ADDENDUM NO. 1

**RE: NCDAC Lumberton Correctional Institution
Air Conditioning Installation
SCO ID#: 22-25591-01A
NCDAC Central Engineering Job Order # 4354**

DATE: June 21, 2023

MECHANICAL DORMITORY "D" PLAN - NEW WORK
 Scale: 1/8" = 1'-0"

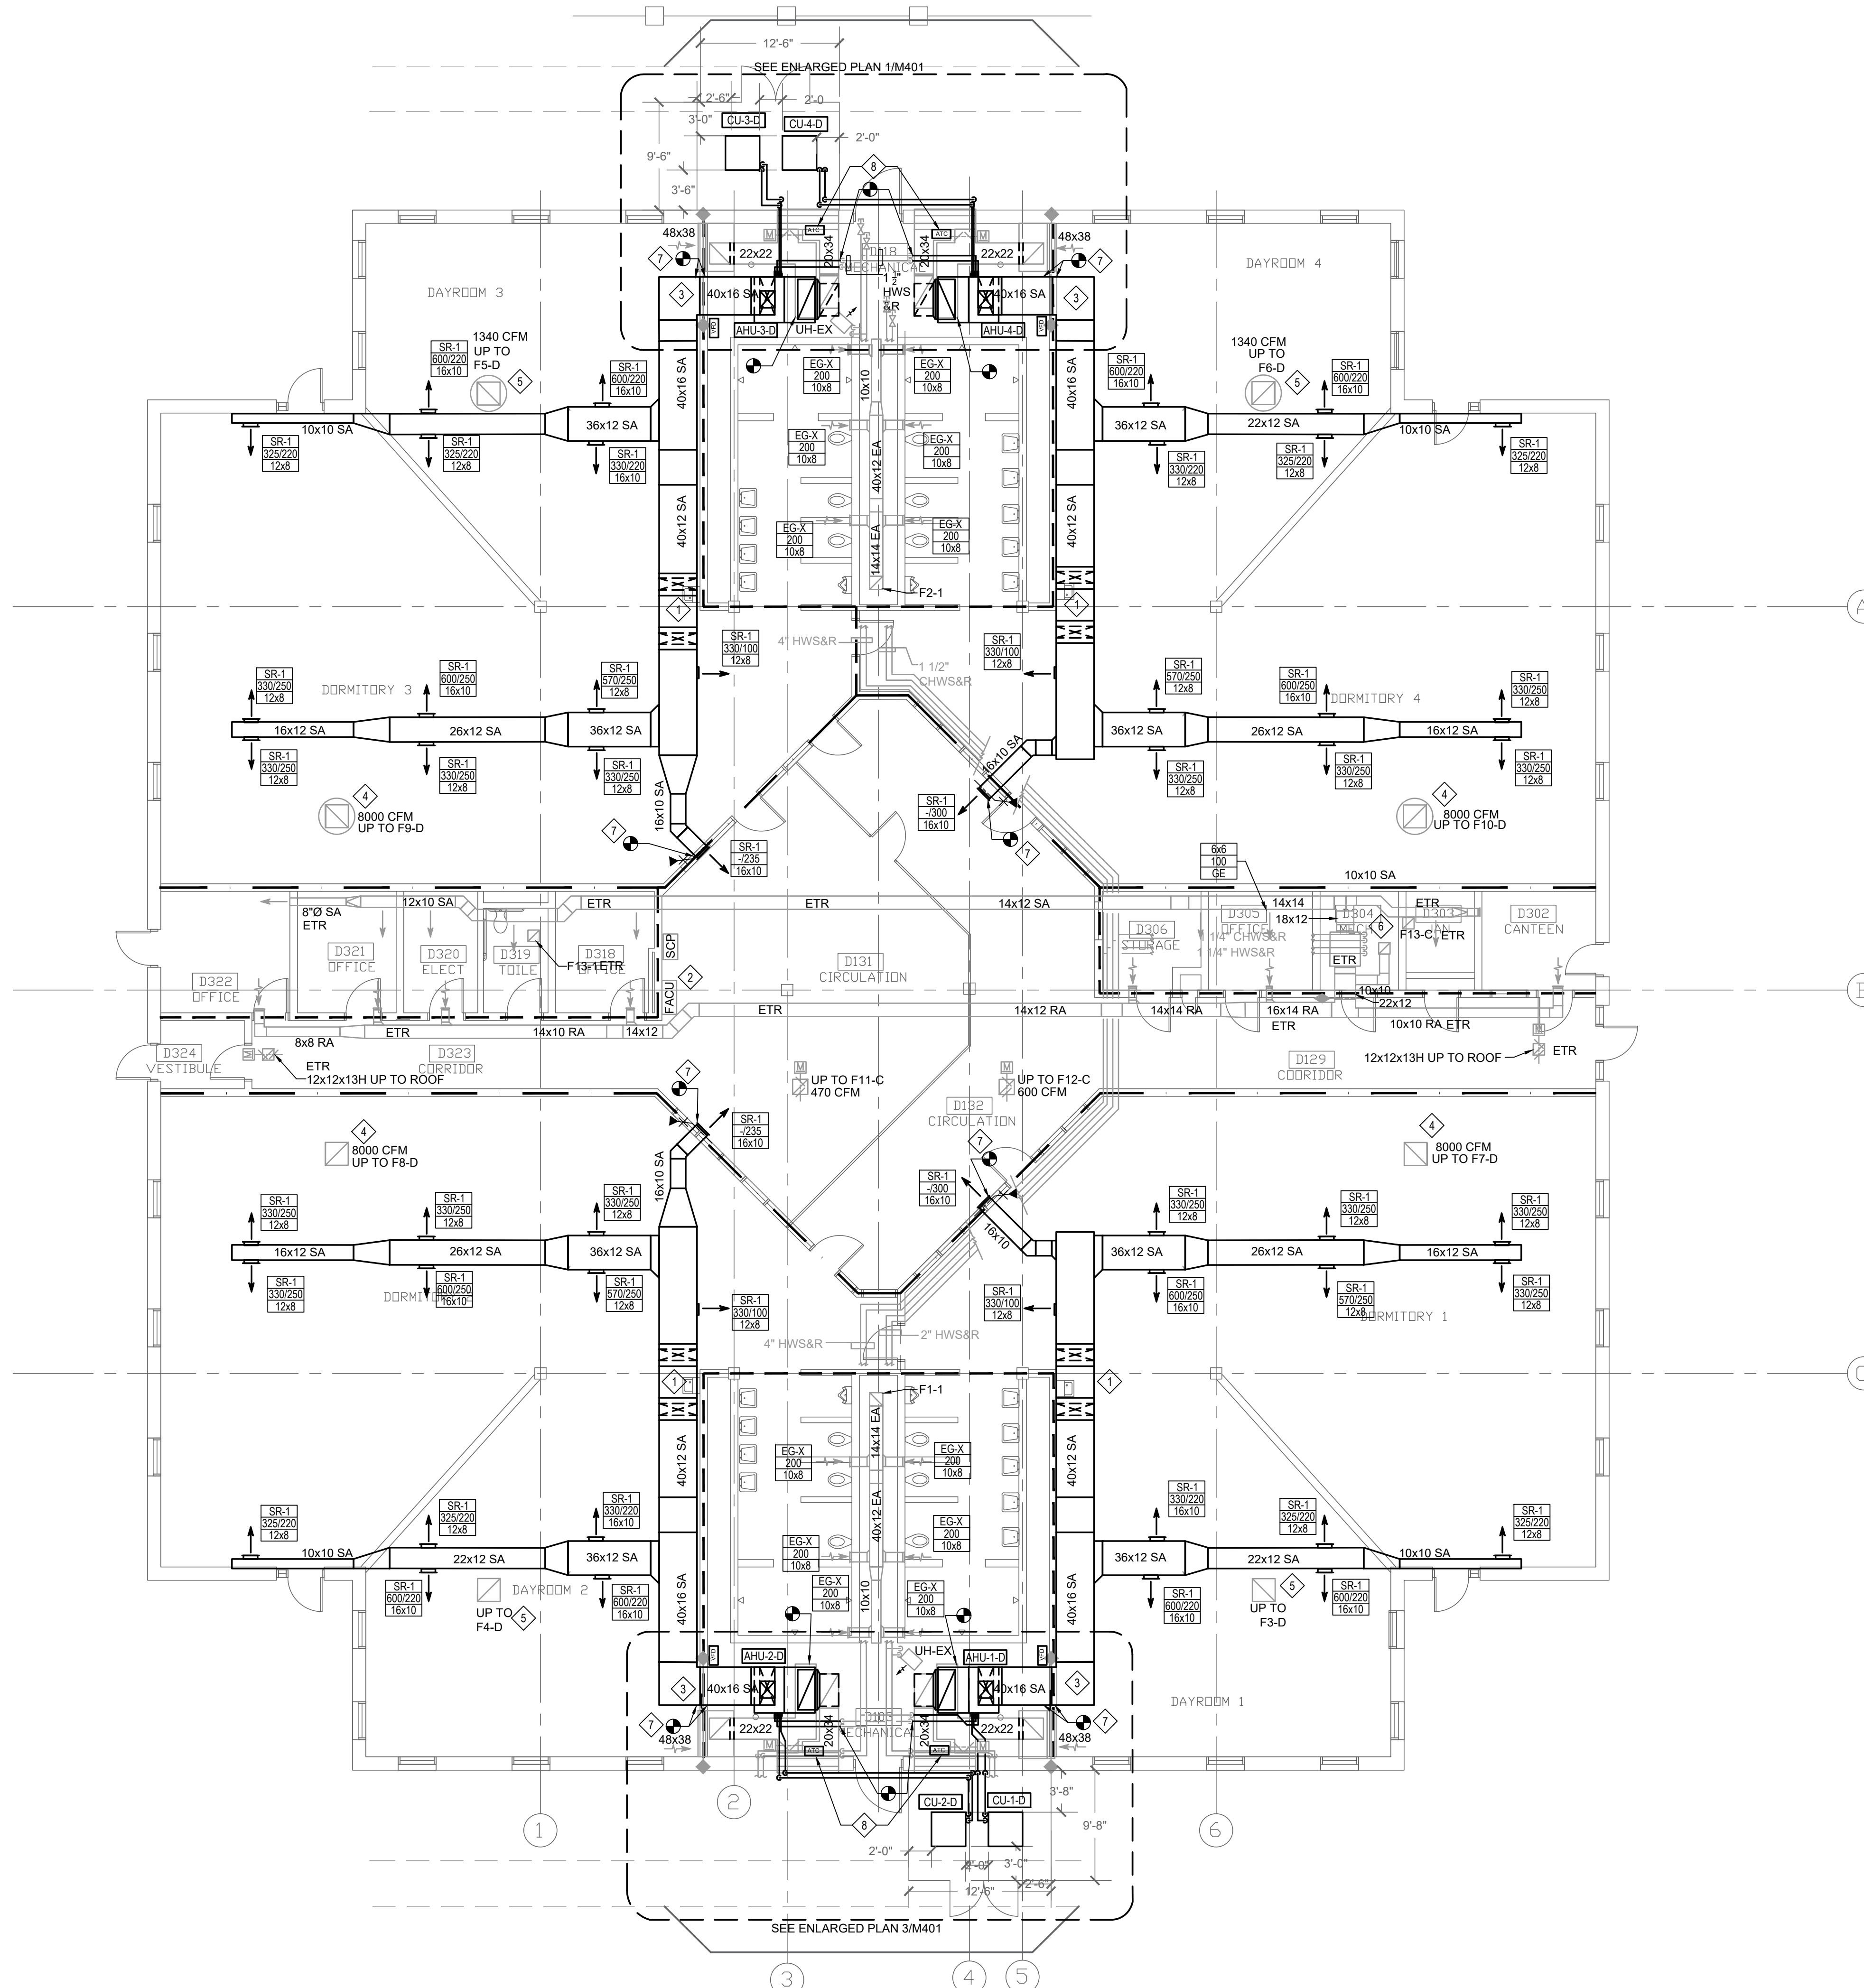
1. Sheet M114: Revised North arrow for floor plan. See attached.
2. Sheet M501: Added sheet M501 to the bid set. See attached.
3. Sheet M502: Revised interlock diagram on detail 3. See attached.
4. Sheet M503: Revised interlock diagram on detail 1. See attached.
5. Sheet M601: Added summary to ventilation table. See attached.

14 CHAIN LINK FENCE

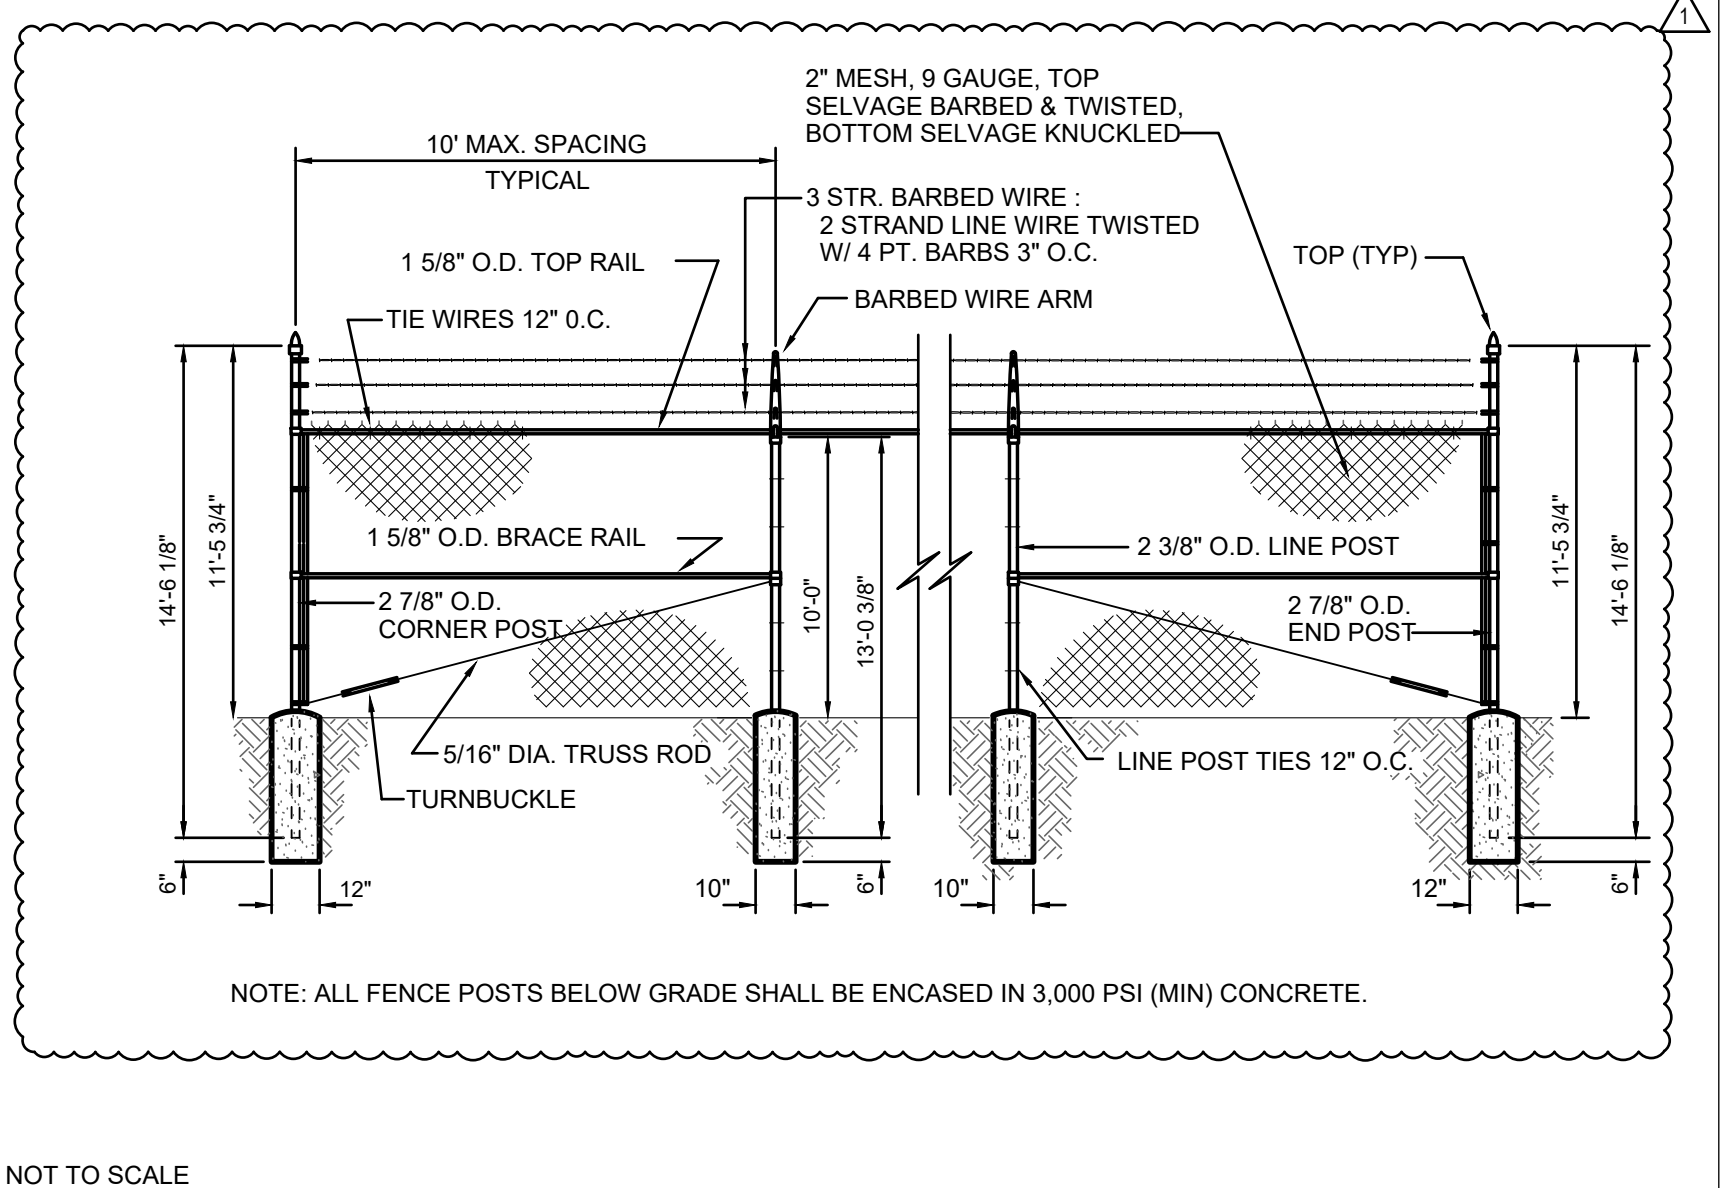
6. Sheet M701: On detail 14, the current design calls for the height of the barbed wire to be 10'-0" above grade. Revise the height of the chain link fence so that the height of the top rail is 10'-0" above grades. The 3 strands of barbed wire shall then be installed above the chain link fence. See attached.
7. Sheet E600: Revised panel schedules/identification. See attached.
8. Sheet E607: Revised sheet number. See attached.
